SOLID WASTE COMPLEX ADMIN BUILDING ADDITION & RENOVATION

ADDENDUM #1

**The Authority – Solid Waste Admin. Building Expansion
PROJECT # 24.007**

ADDENDUM NO. 1

IMAGE - A

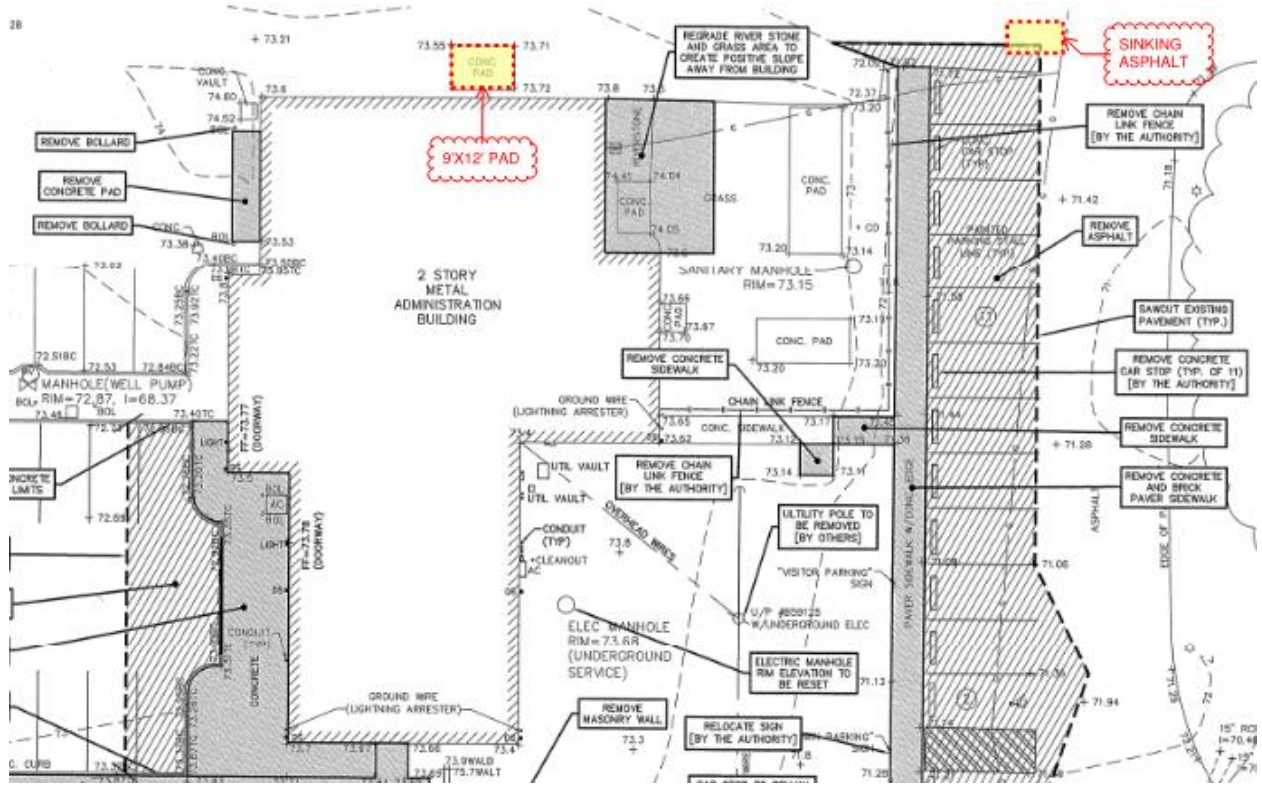
1. Q: Should the existing 9'x12' concrete pad outside of the new lunchroom that sticks out of the ground approx. 4" be demolished?
A: Yes, this concrete pad should be removed down to sound base. Recompact new subgrade. Tack coat faces of excavation with dense-graded, hot-mix asphalt base mix and, while still hot, compact flush with the adjacent surface. Refer to IMAGE – A and specification section 025110 for additional information.

6. Q: Just outside of the front asphalt parking lot there is an area of asphalt that is sinking. Should this be repaired as part of this project and if so, what is the size of this area?
A: This area should be repaired as part of this project. The size of this area is approximately 4'x8'. Refer to IMAGE-A and specification section 025110 for additional information.

IMAGE - B

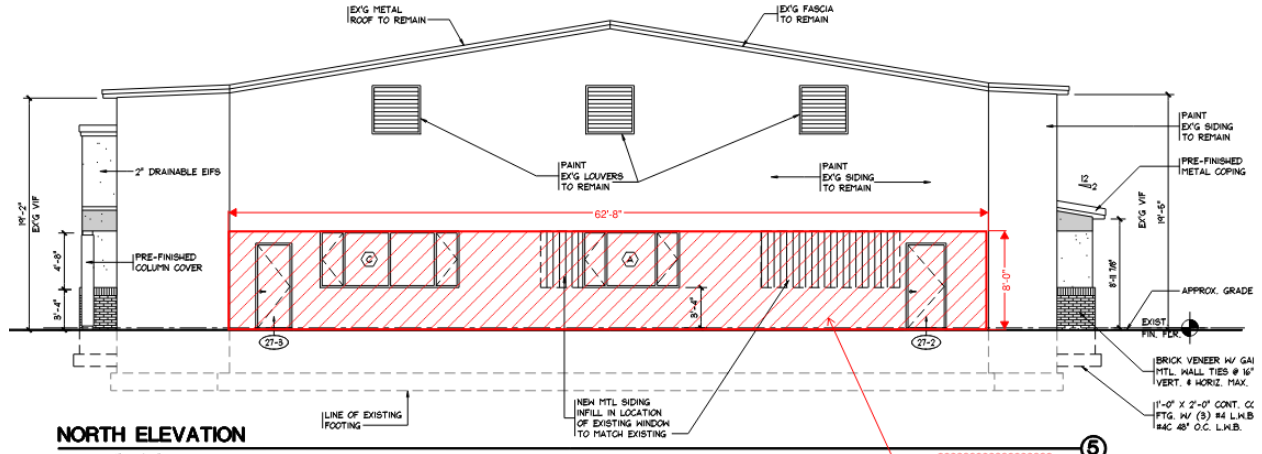
4. Q: During our site visit, it was noticed that the existing metal wall panel on the north side of the building where the existing window units are located is in bad shape. There are numerous holes, dents, and infill trim along the entire base of the wall. Should this area be patched or replaced as required?
A: The entire length of the north wall from the head of the existing windows down to the base of the wall should be removed and replaced with a metal panel to match the existing profile. Refer to IMAGE-B for additional information:

IMAGE - C

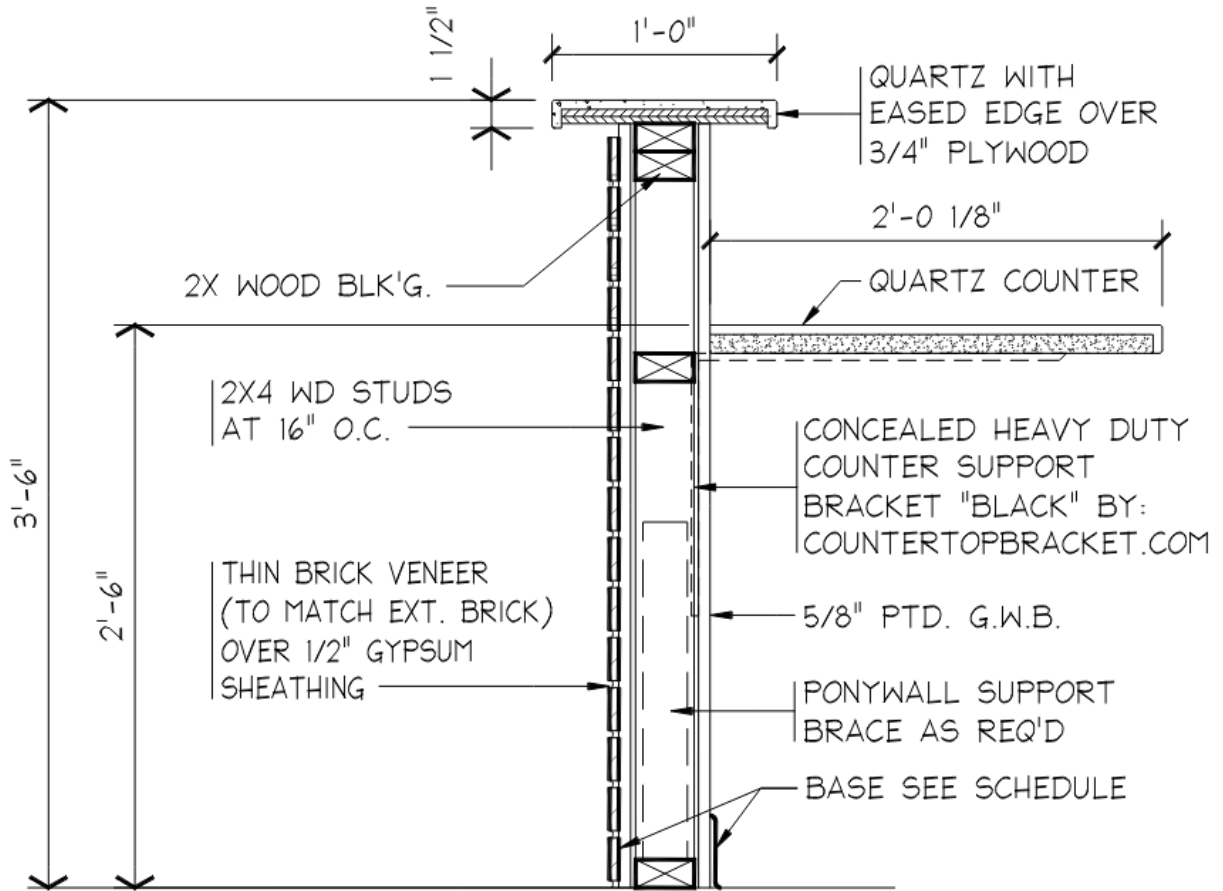
5. Q: Please confirm the finish at the Reception/Administrator half wall. Construction documents call for ptd gwb but at pre-bid, it was mentioned that this will be changed.
A: The outside finish of the half wall is to be a thin brick veneer to match the brick veneer on the exterior of the building. See detail IMAGE-C below:
